Project	IEEE 802.16 Broadband Wireless Access Working Group < http://ieee802.org/16 >	
Title	Comment on Pilot Allocation for 5,6,7 and 8 BS Antennas	
Date Submitted	2004-11-14	
Source:	Wen Tong, Jianglei Ma, Peiyong Zhu, Ming Jia, Dongsheng Yu, Hua Xu, Mo-Han Fong, Hang Zhang, Brian Johnson Nortel Networks 3500 Carling Avenue Ottawa, ON. K2H 8E9 CANADA	Voice: (613)-763-1315 Fax: (613)-765-7723 wentong@nortelnetworks.com
Re:	Response to Sponsor Ballot call for comment	
Abstract	Propose Scattered Pilot Allocation for 5,6,7 and 8 BS Antennas. The update is in blue font	
Purpose	Comment on Scattered Pilot Allocation for 5,6,7 and 8 BS Antennas	
Notice	This document has been prepared to assist IEEE 802.16. It is offered as a basis for discussion and is not binding on the contributing individual(s) or organization(s). The material in this document is subject to change in form and content after further study. The contributor(s) reserve(s) the right to add, amend or withdraw material contained herein.

Comment on Pilot Allocation for 5,6,7 and 8 BS Antennas

Figure 1 scattered pilot pattern for maximum 8 transmit MIMO

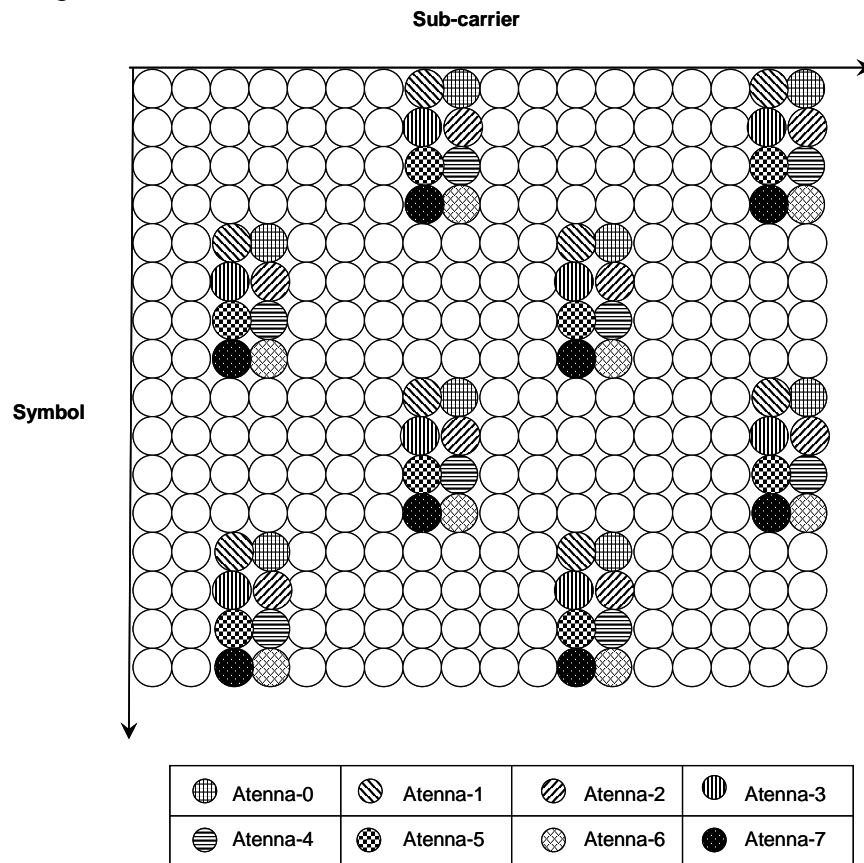
Contribution IEEE C802.16e-04/532 (comment 1527) proposes scattered pilot pattern for 5,6,7, and 8 DL transmit at BS. In this contribution, we propose to use single scattered pilots to support 5,6,7 and 8 antenna MIMO transmission in optional FUSC and optional AMC sub-channel.

The proposed a single pilot pattern is based on the larger coherent time span support for the slow mobility application as shown in Figure 1.
